ATTACHMENT: RESPONSES TO COMMENTS ON THE DRAFT EIR

**FINAL ENVIRONMENTAL IMPACT REPORT FOR THE
PROPOSED WOLFBACK ESTATES PROJECT**

Prepared for the City of Sausalito

December 1989

Figure 13
SITE PORTION PROPOSED
FOR FEDERAL ACQUISITION

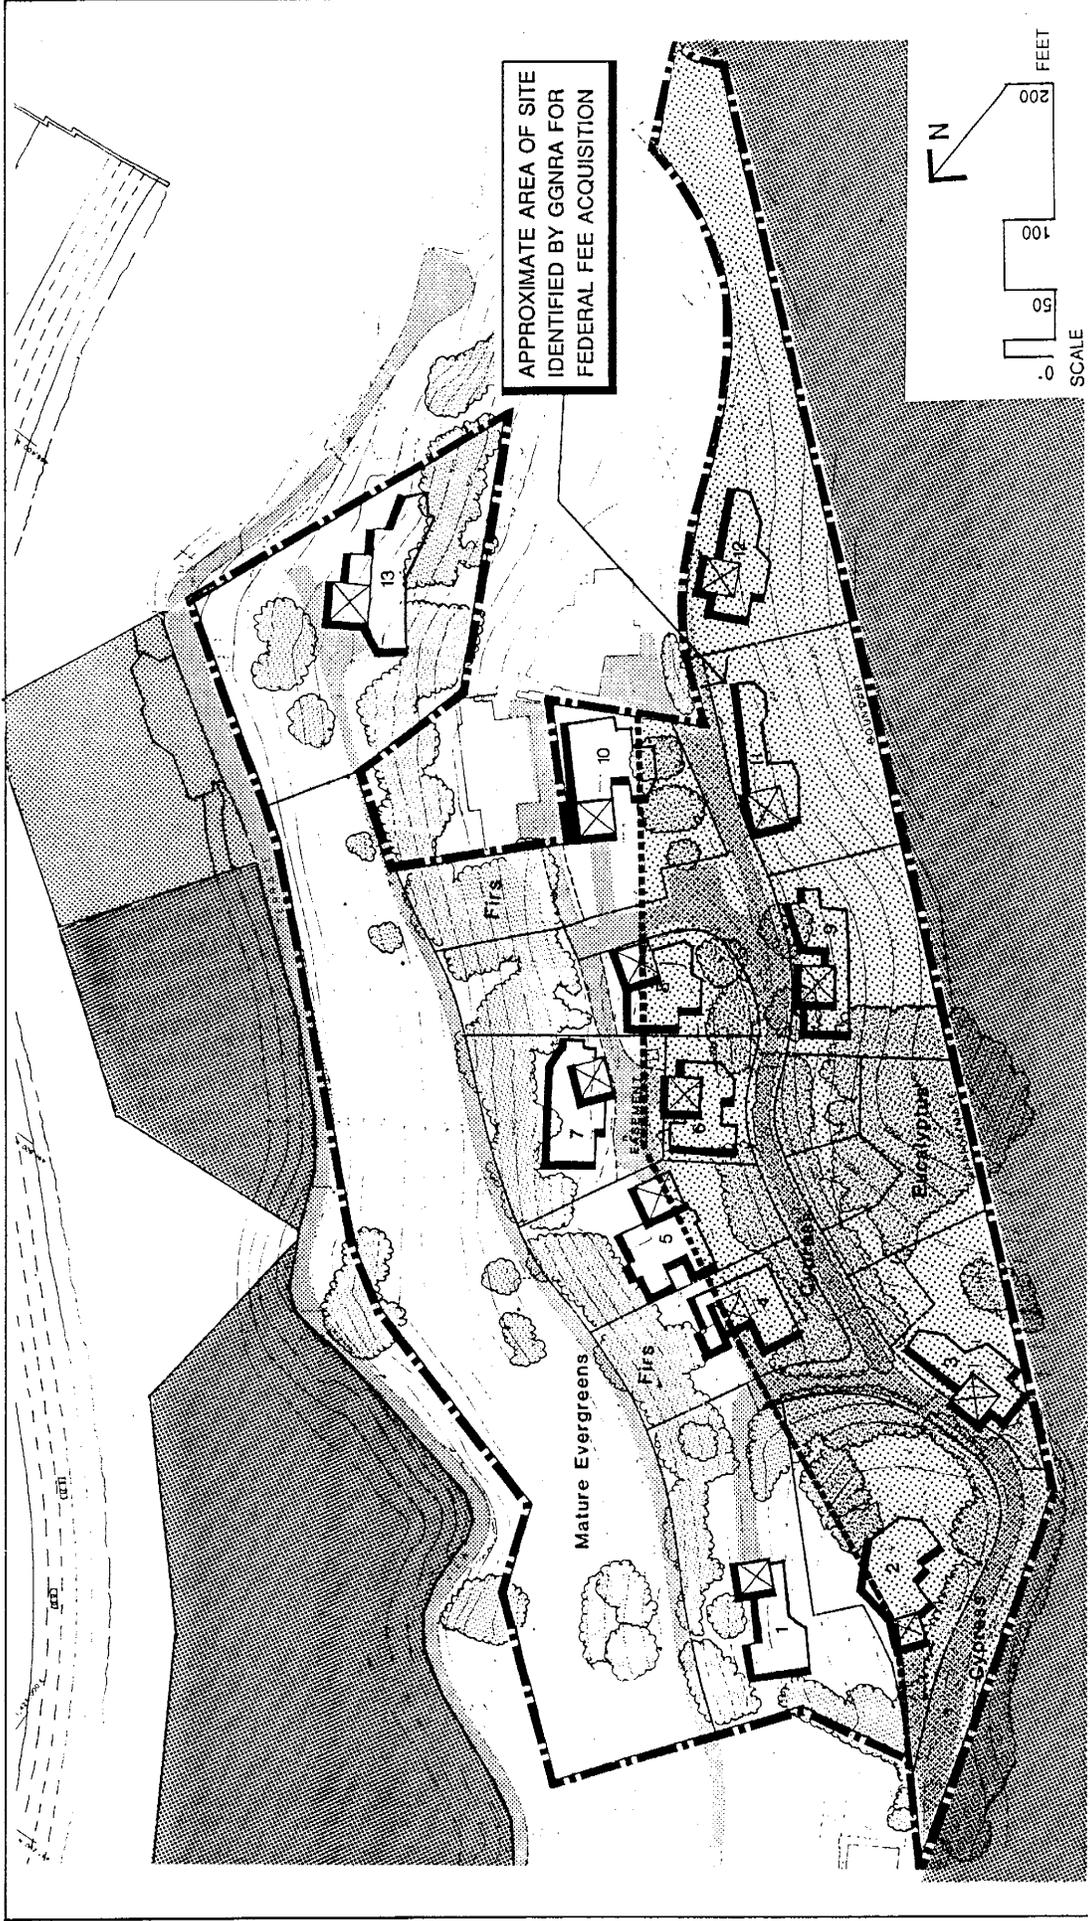
Commissioner Krause questioned Figure 13 and the federal acquisition line. Mr. Wagstaff responded by saying that the property is made up of four parcels and this figure shows 3.3 acres in the GGNRA land protection plan.

Commissioner Seashore advised that there had been a major change in Sausalito's tree ordinance policy. He added that, with regard to Figure 13, it shows the Fritz Warren property as just below lot 13, which is due to be acquired for less then fee. He wondered about the rights on this parcel. Mr. Wagstaff said that his understanding from the information they had received from GGNRA is that this transaction has already taken place and that there is currently some type of conservation easement on this property that accommodates the use that is there now. He added that there is probably some provision to protect the GGNRA use of the house itself. He added that he would verify this.

Commissioner Krause, in looking at Figure 13 in the EIR, wondered if he had a lot of money would he want to spend it on sites 4, 5, 6 and 7, which are grouped close together, and possibly will look out over other persons' roofs, over Sausalito Old Town and the Bay and have freeway noise problems, etc., or would he want 9, 11 and 12, where because of GGNRA he would get a wonderful view and sunset that no one is going to be able to build on. He thought that, arguably, the west lots are potentially the most valuable ones, because they have the view over something that will never be spoiled. He thought it a real gamble, relative to the project, to be faced with having to approve a thirteen-unit project in a situation where it is not certain that GGNRA will ever buy what may be the most valuable property of the thirteen.

40. The Commissioner's comments were adequately responded to John Wagstaff at the hearing. No further written response is necessary.
41. Figure 13 has been revised for clarity.

r The project site portion schematically designated in the GGNRA plan for fee simple acquisition includes the area occupied by proposed lots 3, 9, 11, and 12 on the west-facing slope, plus all of ridgetop lot 6, the extension of Wolfback Ridge Road, and portions of ridgetop lots 2, 4, 5, 8, and 10. (See Figure 13 on page 11 of section IV.A.) If acquisition of APN 200-13-10 went ahead as proposed, with provisions for maintaining Wolfback Ridge Road access to the remaining project lots, the development capacity of the remaining project property (4.5 acres) would be reduced to between four units (assuming onsite septic drainage fields) to nine units (assuming an easement for up to four offsite septic drainage fields within the GGNRA acquired 3.31-acre portion of the site).

Figure 18
SITE VISUAL IMPACT VULNERABILITY

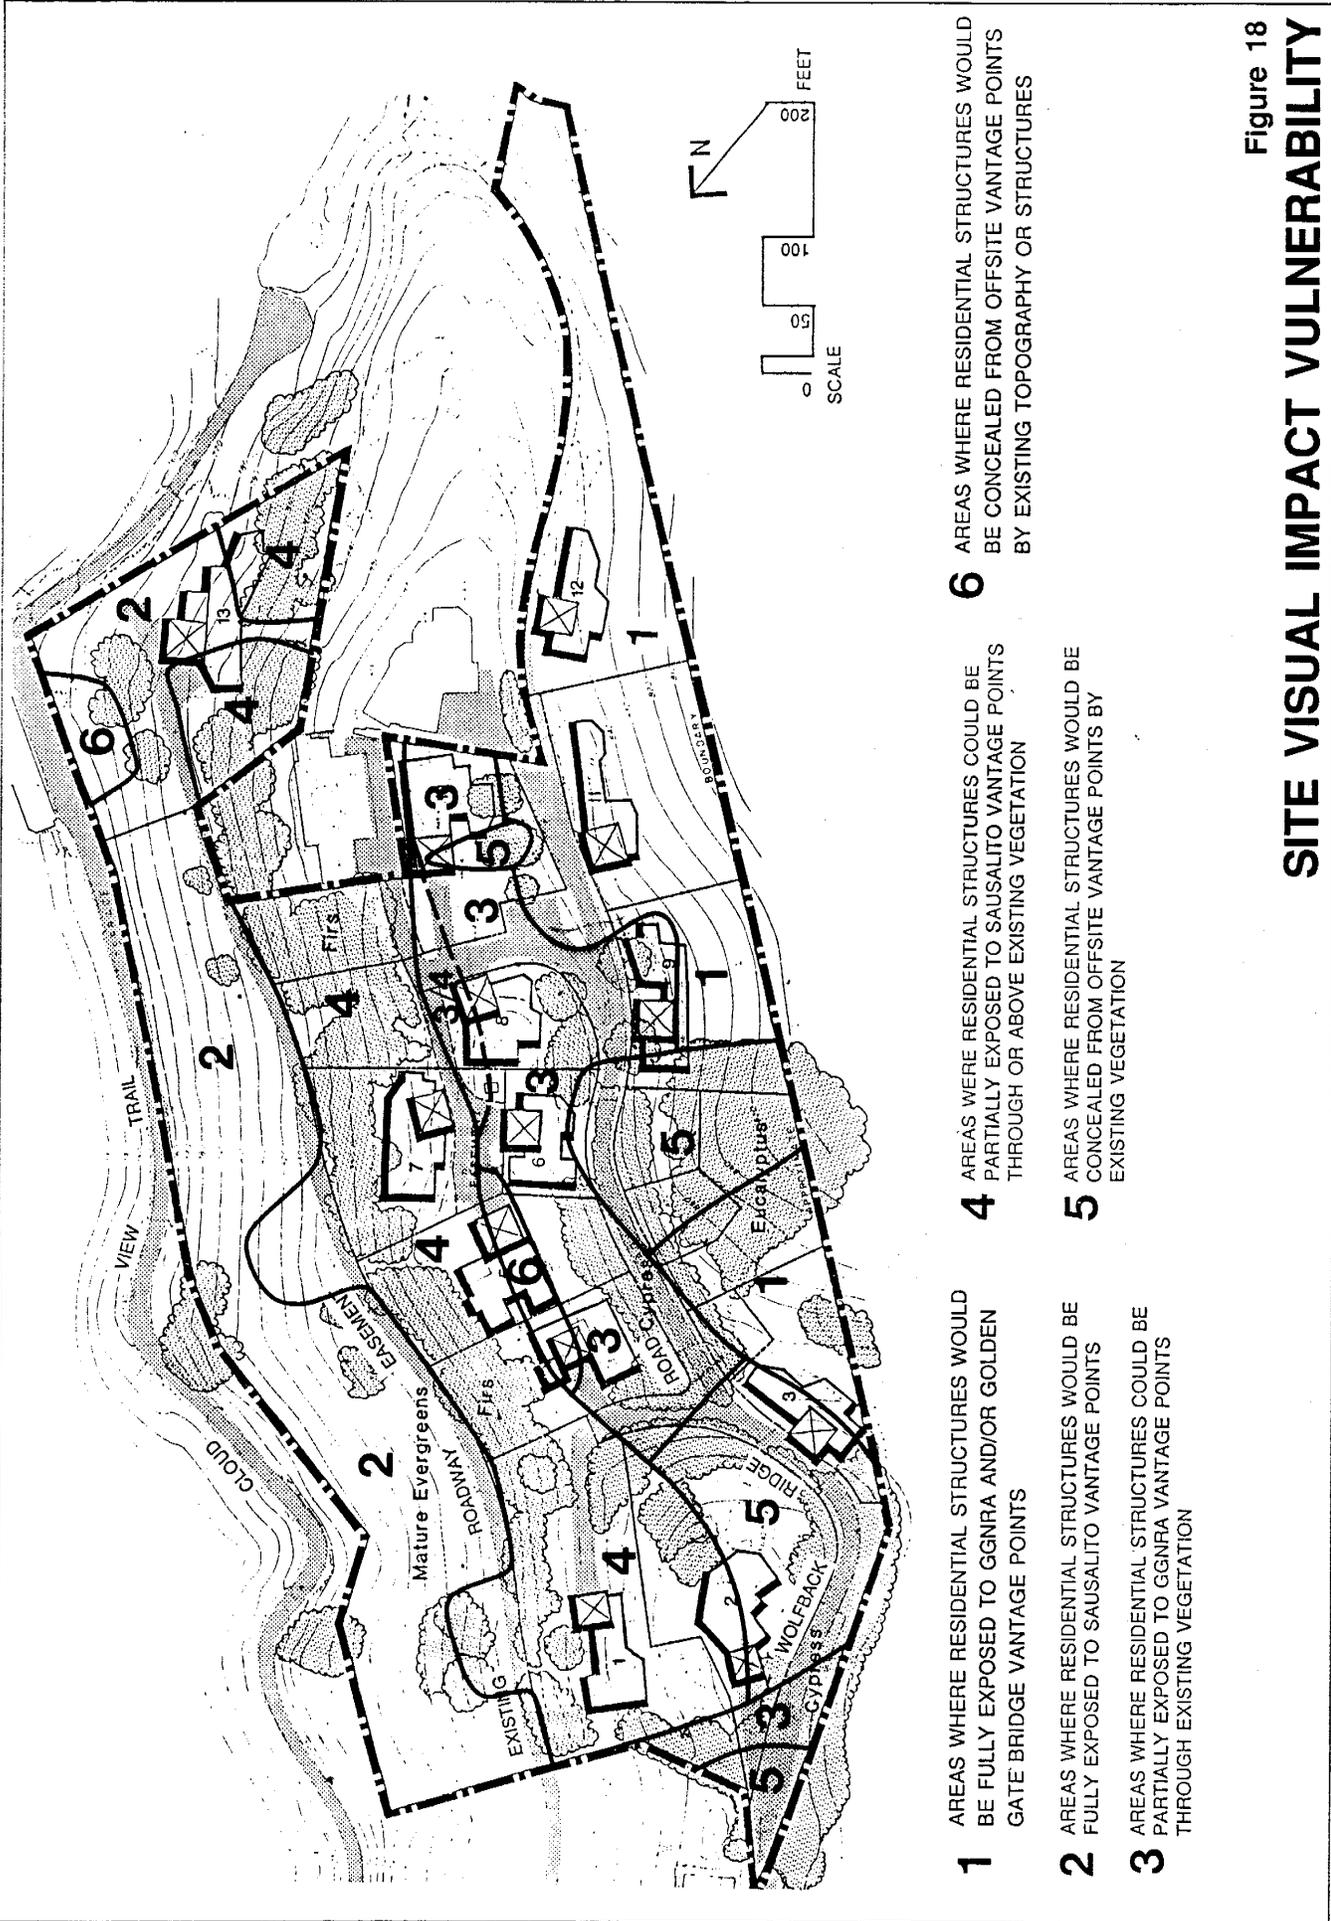
With regard to visual concerns, Figure 18, Mr. Wagstaff stated that the EIR points out that five lots would have a significant visual impact. On the ocean side this would include lots 9, 11 and 12. They would be highly exposed to GGNRA vantage points. Ocean side lot 3 contains some existing vegetation but none that would adequately screen it from vantage points of GGNRA. On the Bay side of the project lot 13, at the end of Wolfback Terrace, a portion of that structure would be highly exposed to views from Sausalito. The applicants' landscape plan proposes the introduction of a screen of trees for lots 9, 11 and 12. The EIR determines that this screen would take at least five years to mature and in the interim the units would be exposed. There is a concern that new homeowners would remove or thin out existing vegetation to enhance their views.

54. Comment acknowledged. (See responses to letters 15 and 29.)
55. The DEIR includes a detailed, lot-specific, and adequate discussion of the visual implications of tree and branch removal for view enhancement purposes on pages 71, 72, 73 (Figure 18), 75, 78 (Table 3), 88 and 89.

Figure 24
EXISTING WOLFBACK RIDGE ROAD SYSTEM

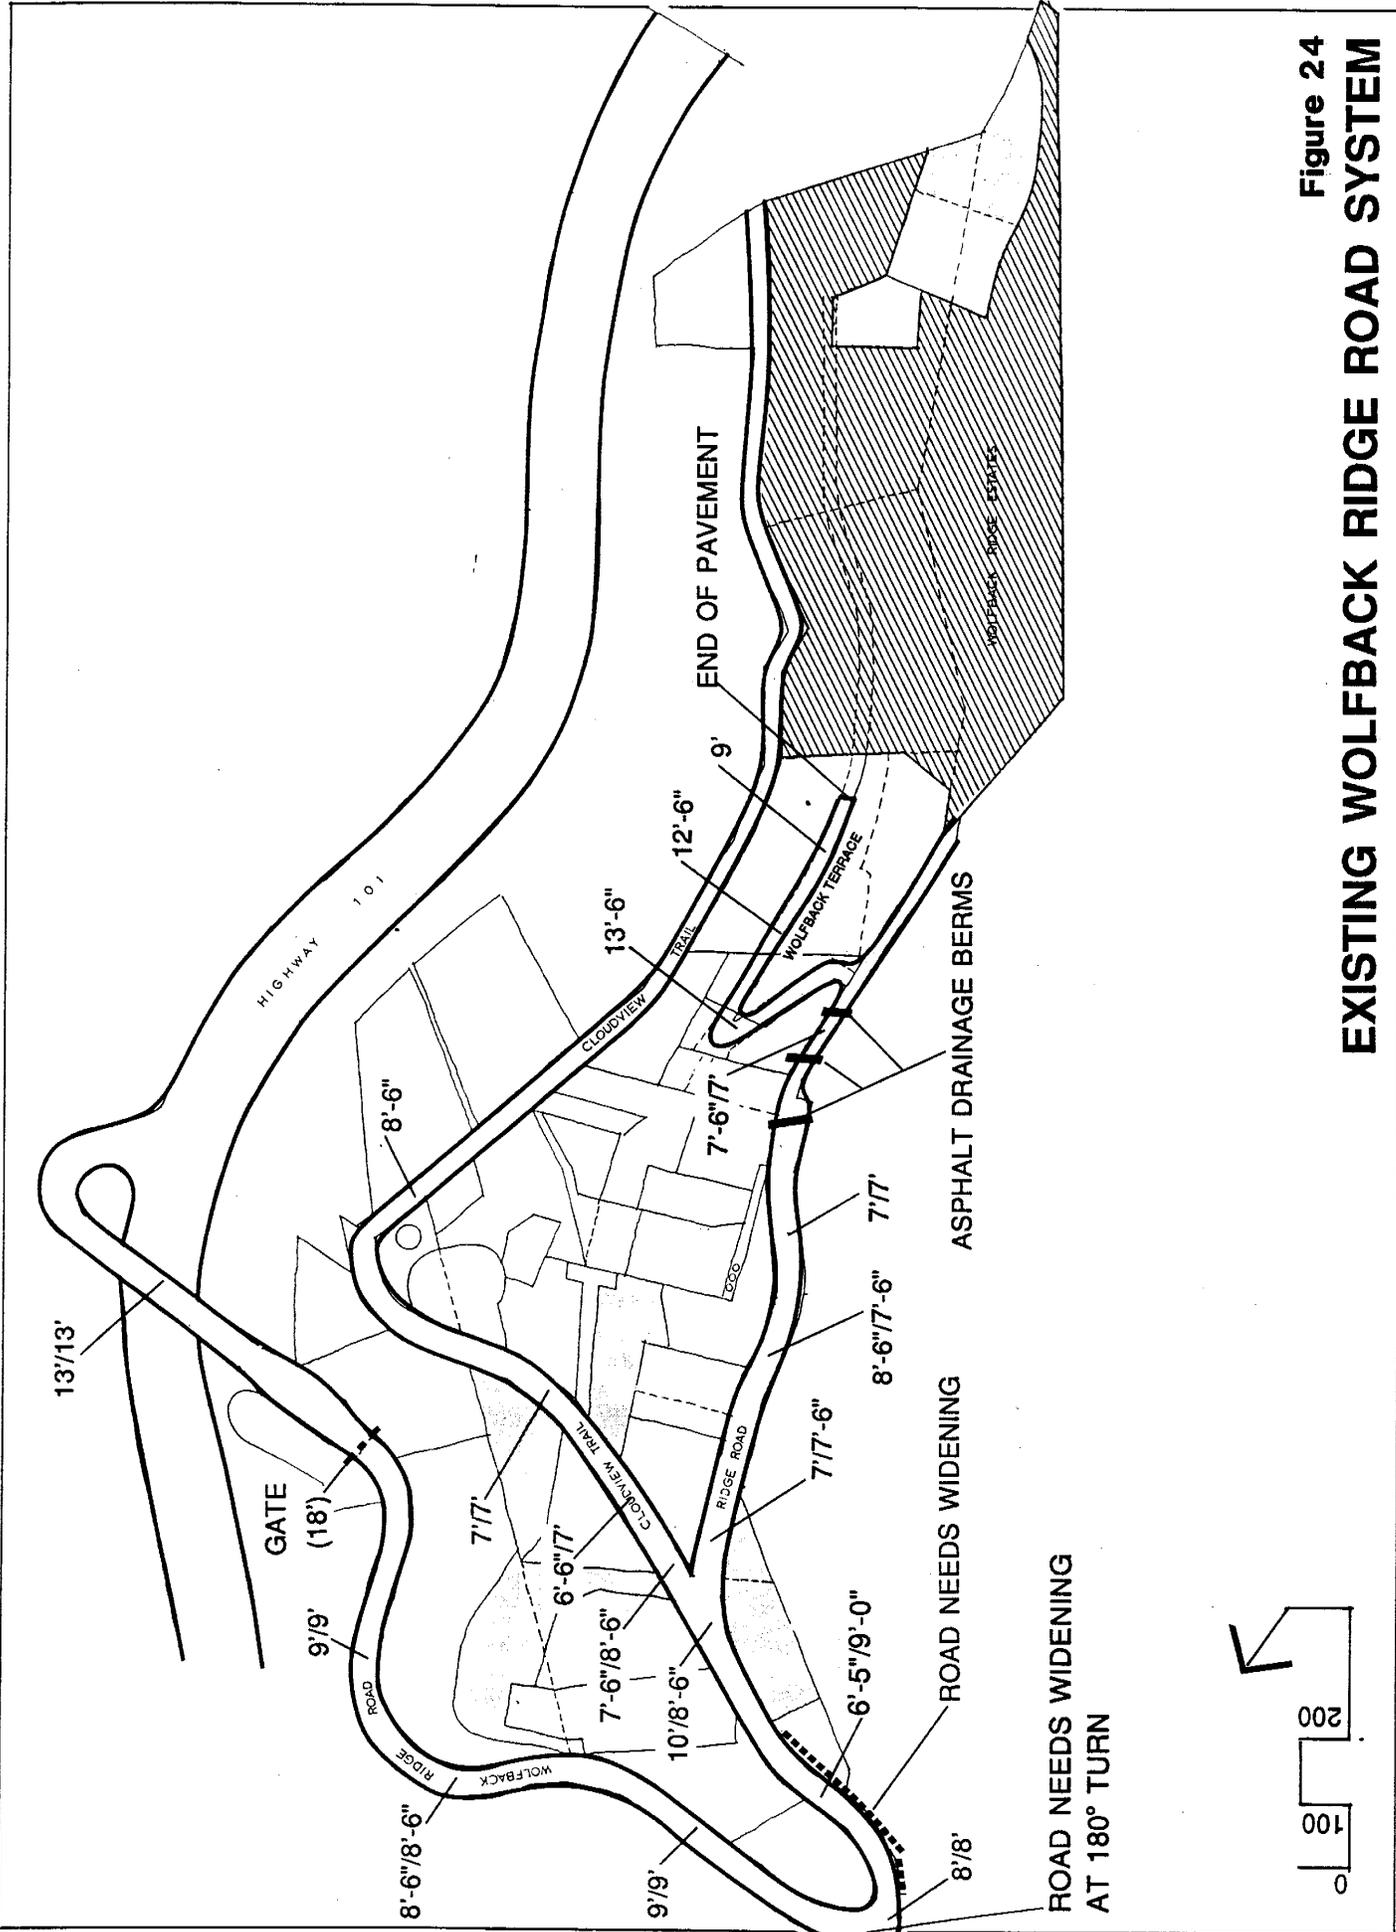
Figure 3 Page 30 and Figure 24 Page 93 accurately depicts the city right of way but does not illustrate the paved portion which is to the East of the right of way. The paved portion departs at the "u" in Cloud and rejoins the right of way at the "l" in "US 101" on Fig 3.

Commissioner Seashore pointed out another error in the EIR, Figure 24, which fails to show the extension of Wolfback ridge Road through the proposed development.

83. No further response necessary.
84. Comments noted (do not pertain to adequacy of the DEIR).
85. Other figures in the DEIR (Figures 4, 5, 9, and 7) as well as the DEIR text, adequately convey the fact that Wolfback Ridge Road extends into and through the project site as a driveway serving the project site.

r The portion of Cloud View Trail northeast of the "Beacon Hill" MMWD water tank (see
r Figure 3 and 24) lies within a right-of-way owned by the city. The portion south of the tank
r lies mostly on land owned by the GGNRA, with the exception of two small segments which
r are within the Highway 101 right-of-way (see Figure 3). The portion of the route south of
r the tank labelled on the cover of this EIR and on Figures 3, 7, 11, 12, 14, 15, 18, 24, and
r 25 as "Cloud View Trail," is in fact a private access drive serving the Warren residence at
r 509 Cloud View Trail (just below proposed lot 13). The private access drive has been
r established based upon an access easement agreement between the GGNRA, Mr. Fritz
r Warren, and his assigns. The access drive was improved by and is currently maintained by
r Mr. Warren. Mr. Warren has reported that he believes he has an exclusive right to
pedestrian and vehicular access across those portions of Cloud View Trail that traverse
